ADDENDUM NO. 1A

Good Shepherd Catholic Church Community Center

July 27, 2026

GRC Project 21275

D	GAS WATER HEATER
---	------------------

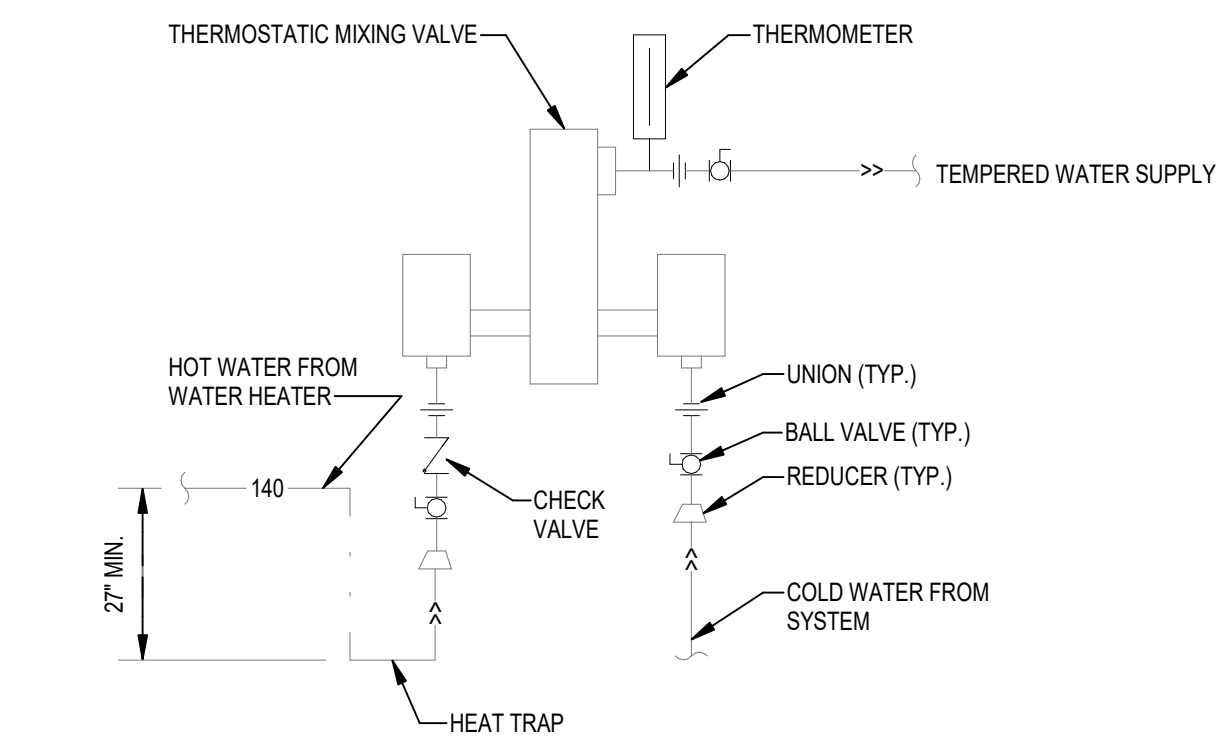
Item P1.1.14 **Revise** Gas Water Heater detail (D/P5.02).
